CNL-15-128

Sequoyah Nuclear Plant, Units 1 and 2
Facility Operating License Nos. DPR-77 and DPR-79
NRC Docket Nos. 50-327 and 50-328

Subject: **Sequoyah Nuclear Plants, Units 1 and 2 Technical Specifications
Conversion to NUREG-1431, Rev. 4.0 (SQN-TS-11-10) - Supplement 2**

**Sequoyah Nuclear Plant, Units 1 and 2 Technical Specifications Conversion to
NUREG-1431, Rev. 4.0 (SQN-TS-11-10) - Revision 1**

Figure B 3.1.6 (page 1 of 1)
Control Bank Insertion vs. Percent RTP

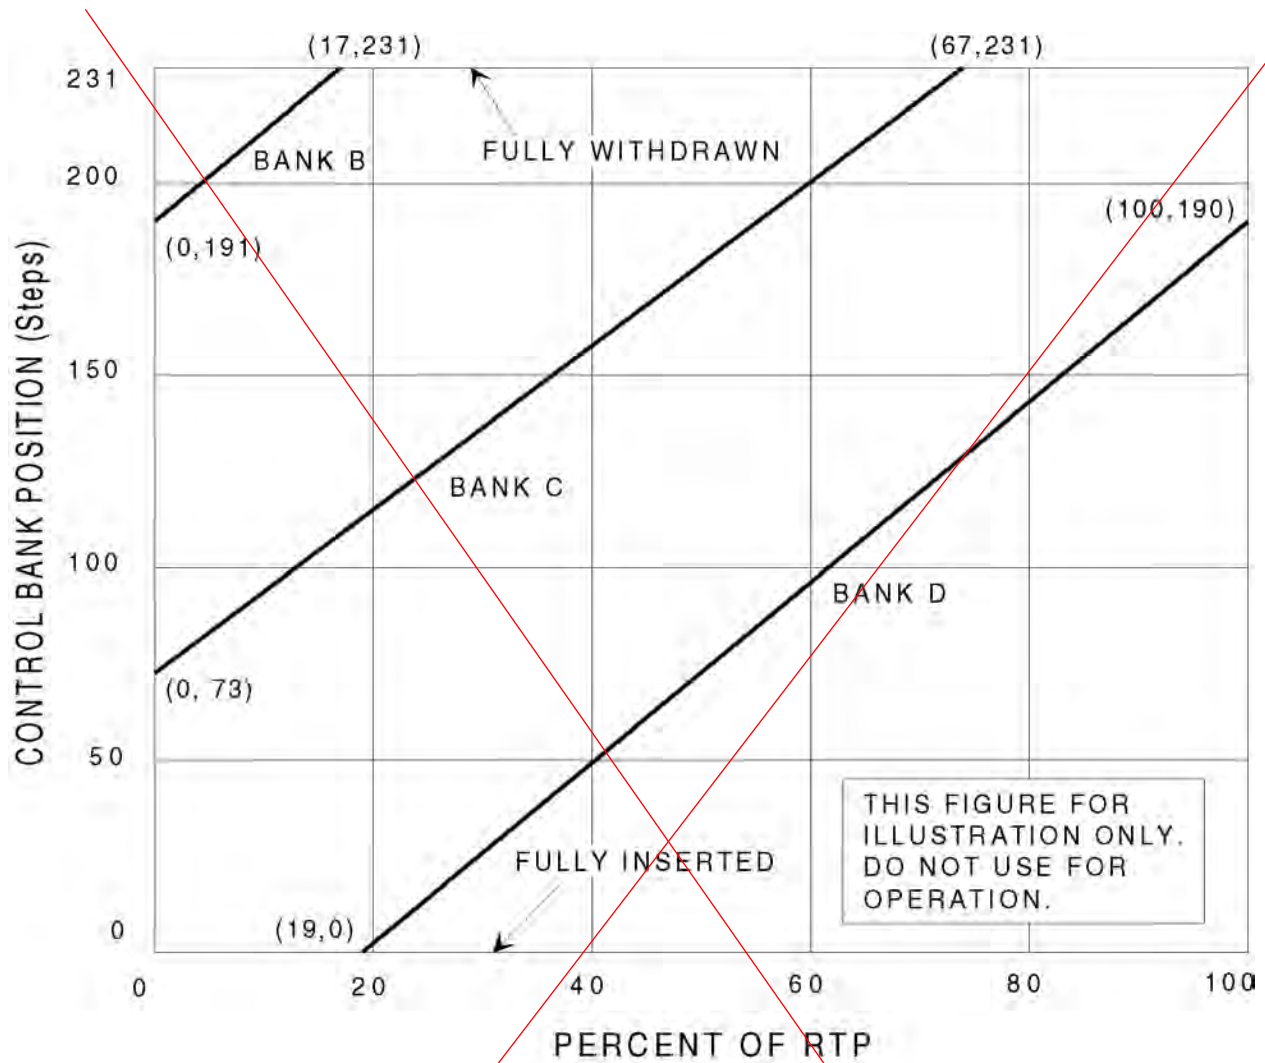
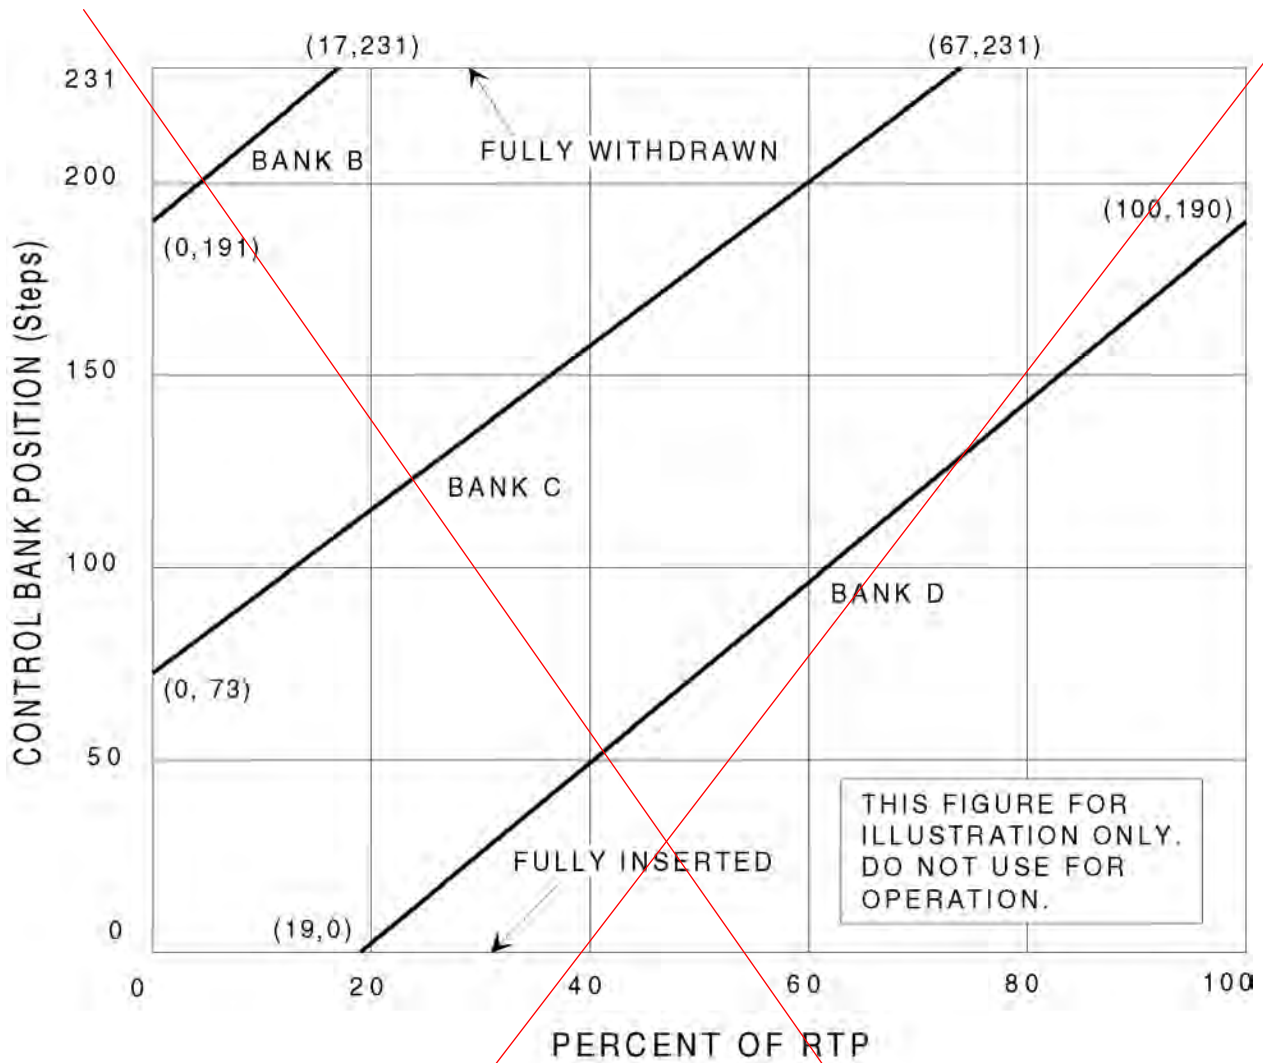
The control bank insertion limits are specified in the COLR. ~~An example is provided for information only in Figure B 3.1.6-1.~~ The control banks are required to be at or above the insertion limit lines.

~~Figure B 3.1.6-1 also indicates how the control banks are moved in an overlap pattern.~~ Overlap is the distance travelled together by two control banks. The predetermined position of control bank C, at which control bank D will begin to move with bank C on a withdrawal, ~~will be at 118 steps for a fully withdrawn position of 231 steps.~~ The fully withdrawn position is defined in the COLR.

2. ISTS 3.1.6 contains Figure B 3.1.6-1 and states that it is an example provided for information only. ITS 3.1.6 does not include Figure B 3.1.6-1. The control bank insertion limits for Sequoyah Nuclear Plant (SQN) are located in the COLR. Therefore, ISTS Figure B 3.1.6-1 and the references to the ISTS Figure B 3.1.6-1 have been deleted.

Figure B 3.2.3B-1 (page 1 of 1)
AXIAL FLUX DIFFERENCE Acceptable Operation Limits
as a Function of RATED THERMAL POWER

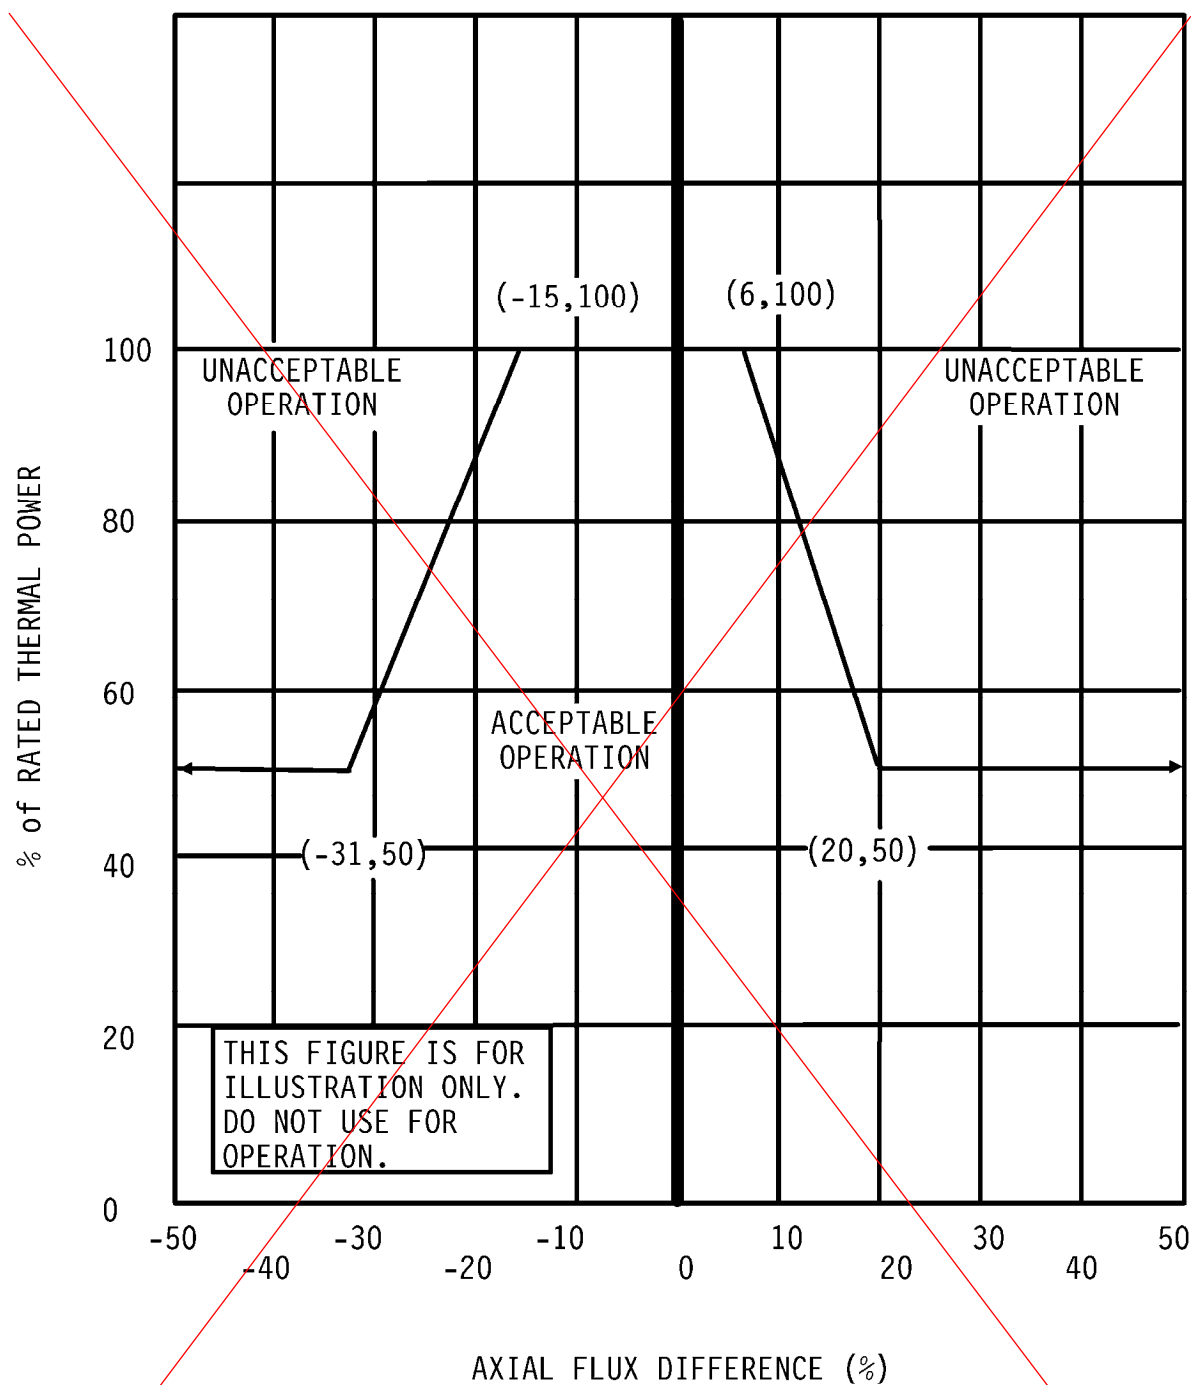
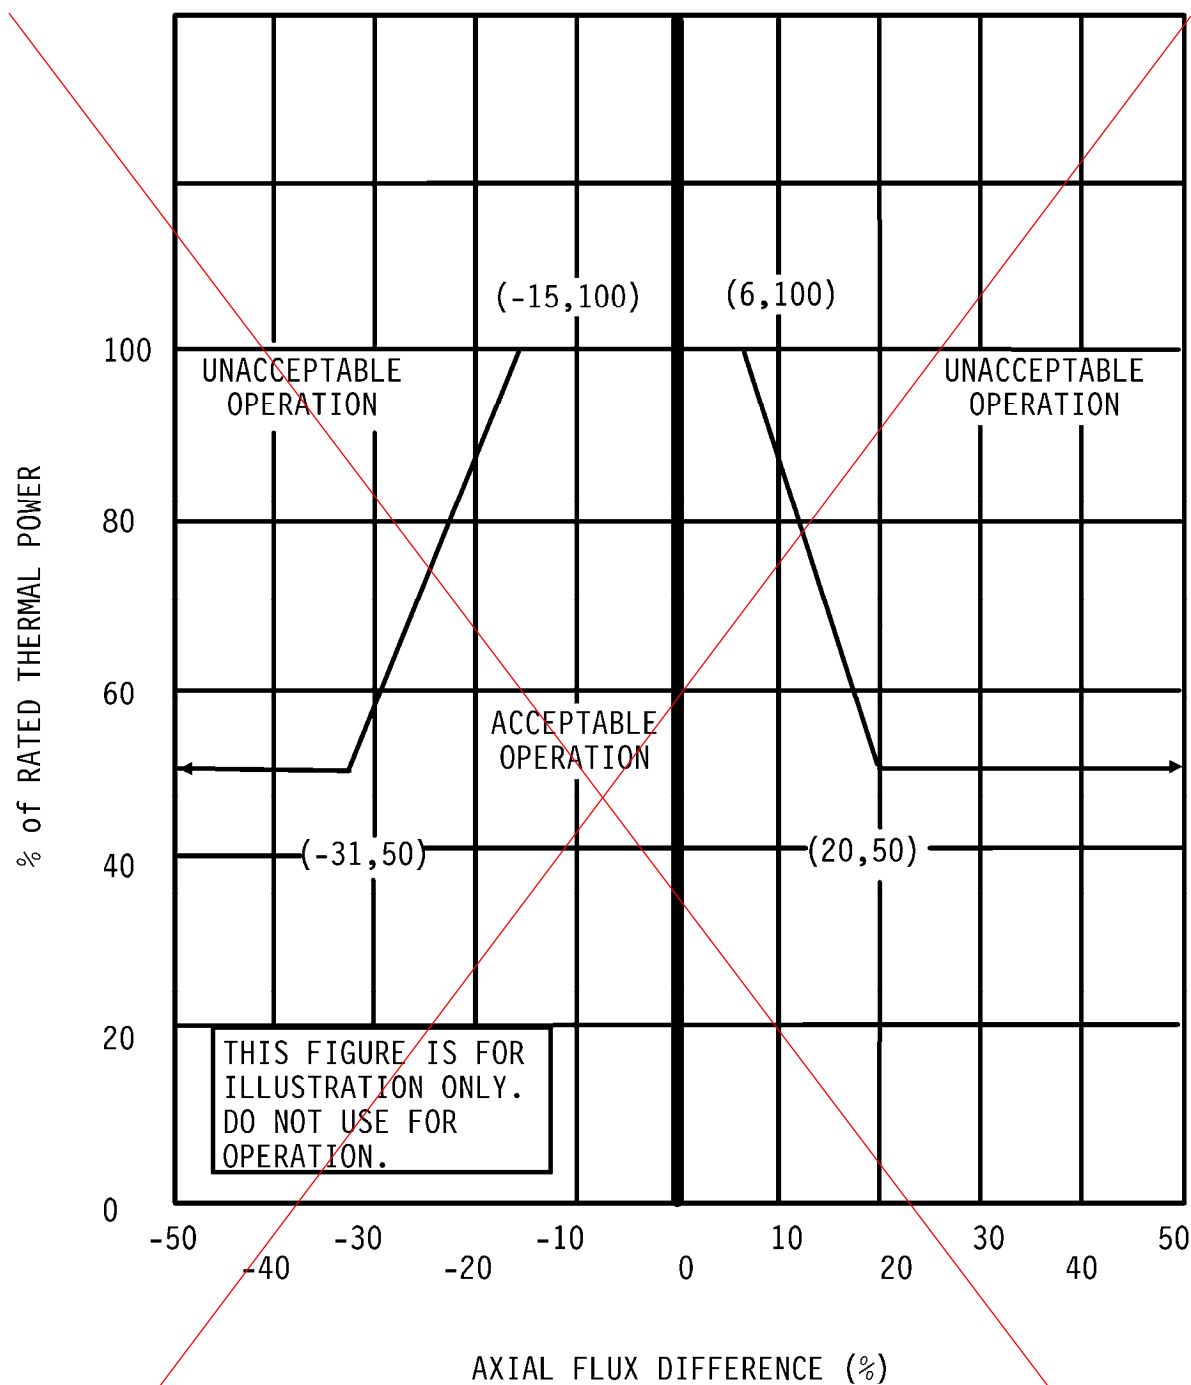
The AFD limits are provided in the COLR. ~~Figure B-3.2.3B-1 shows typical RAOC AFD limits. The AFD limits for RAOC do not depend on the target flux difference. However, the target flux difference may be used to minimize changes in the axial power distribution.~~

5. ISTS 3.2.3 Bases contains Figure B 3.2.3B-1. This Figure is located in the Sequoyah Nuclear Plant (SQN) COLR. Therefore, this figure is not included in the Bases for ITS 3.2.3.

~~Figure 3.2-1 Flow vs. Power for 4 Loops in Operation~~

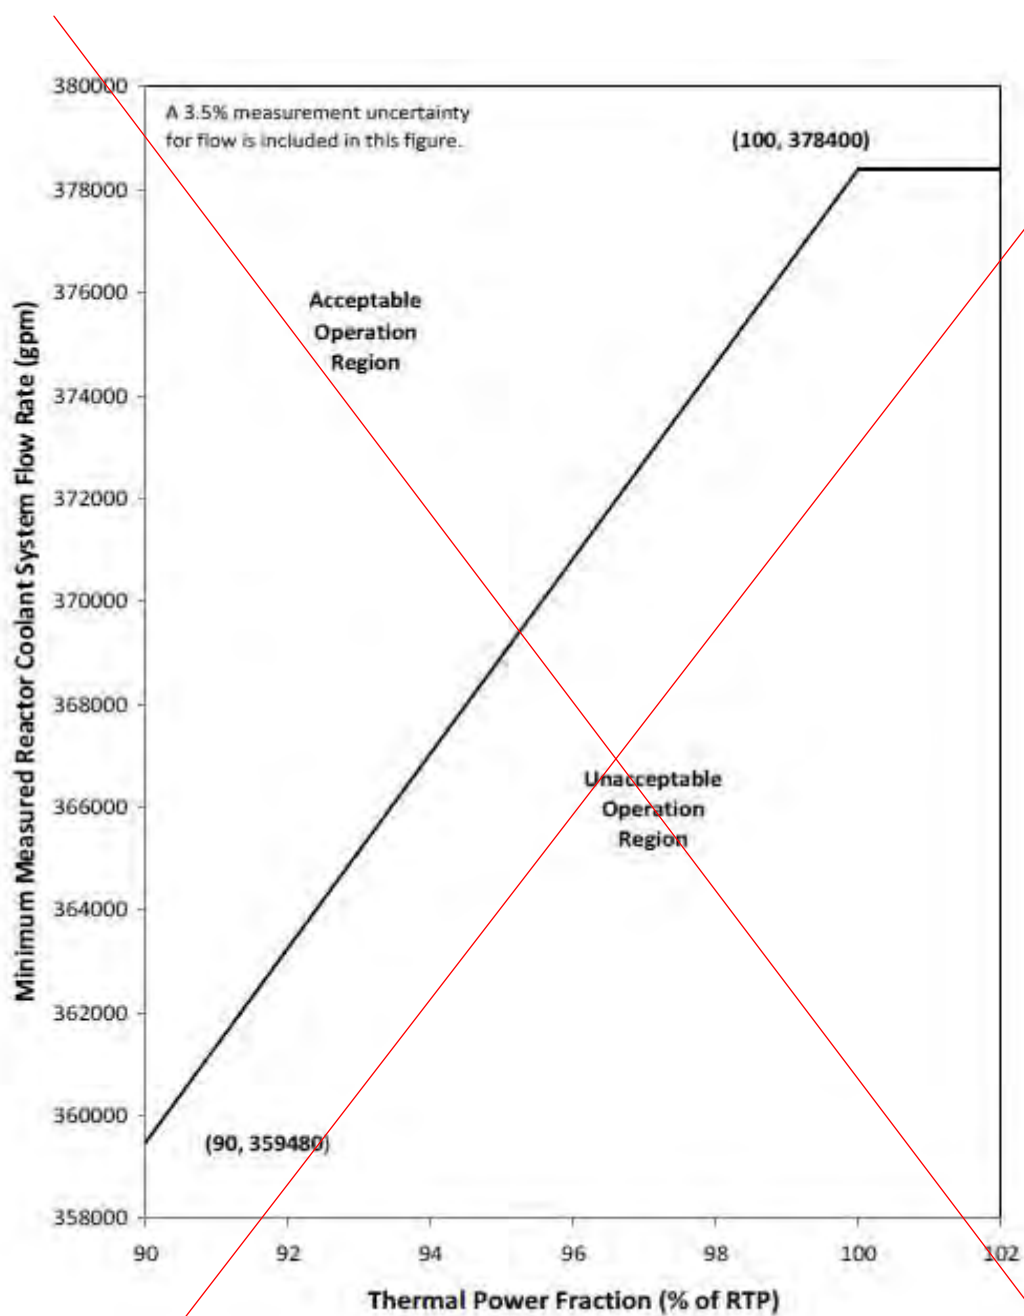
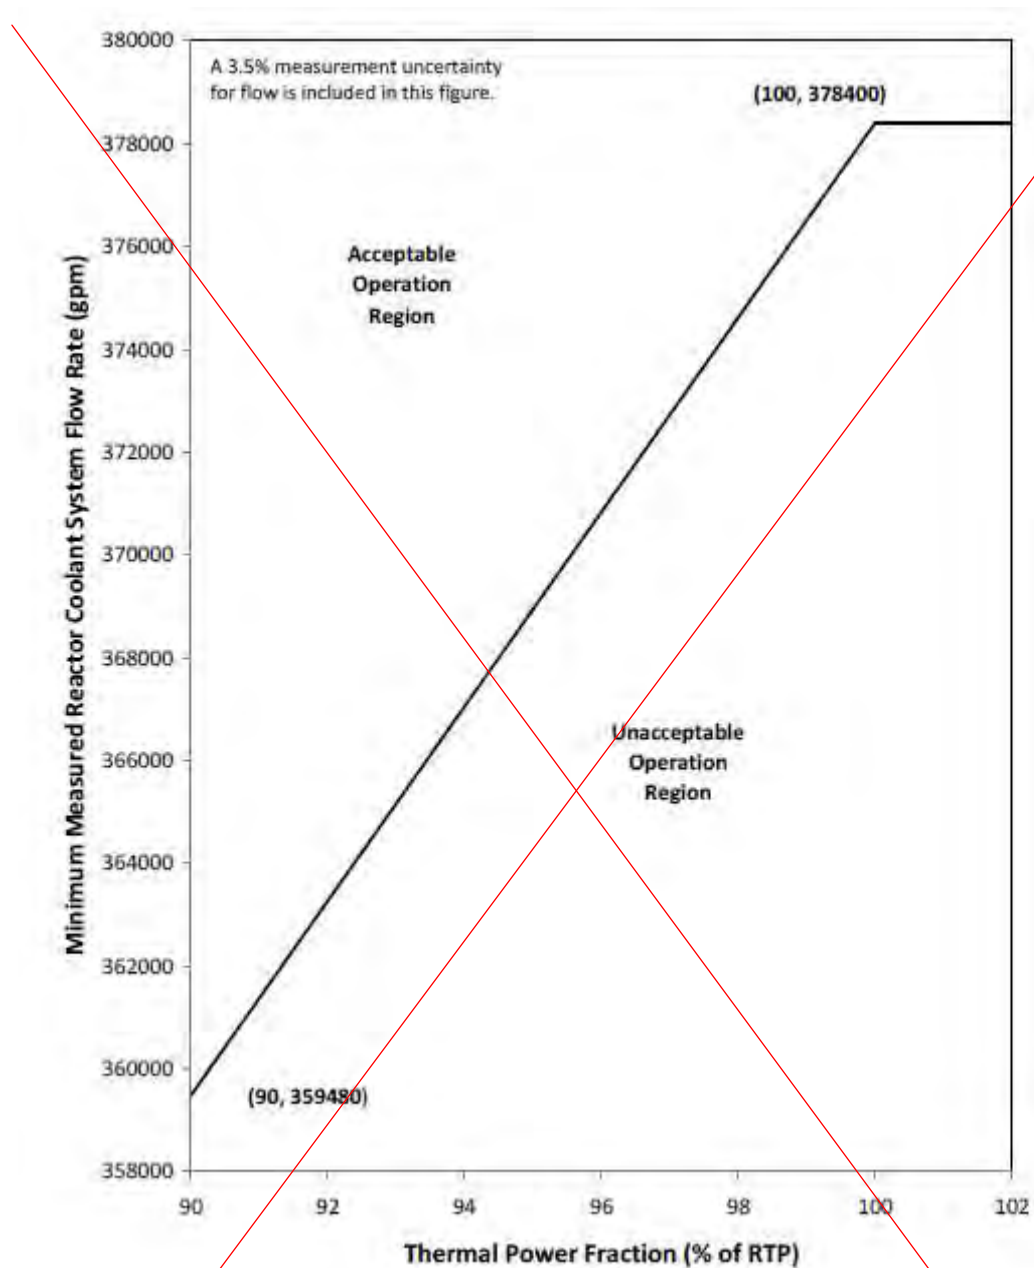
~~$\leq 2220 \text{ psia}^*$~~ ~~Figure 3.2-1~~~~378,400 gpm~~

CTS Figure 3.2-1 Flow vs. Power for 4 Loops in Operation provides the acceptable Minimum Measured Reactor Coolant System Flow Rate (measured in gallons per minute (gpm)) based on the Thermal Power Fraction (% of Rated Thermal Power (RTP)). The Acceptable Operation Region covers flows from 100% RTP (minimum RCS flow rate 378,400 gpm) to 90% RTP (minimum RCS flow rate 359,480 gpm). ITS LCO 3.4.1 does not include a figure for a minimum acceptable RCS flow rate. ITS LCO 3.4.1 requires RCS total flow rate to be greater than or equal to the required flow for 100% RTP. This changes the CTS by not allowing the RCS total flow rate to be < 378,400 in MODE 1.
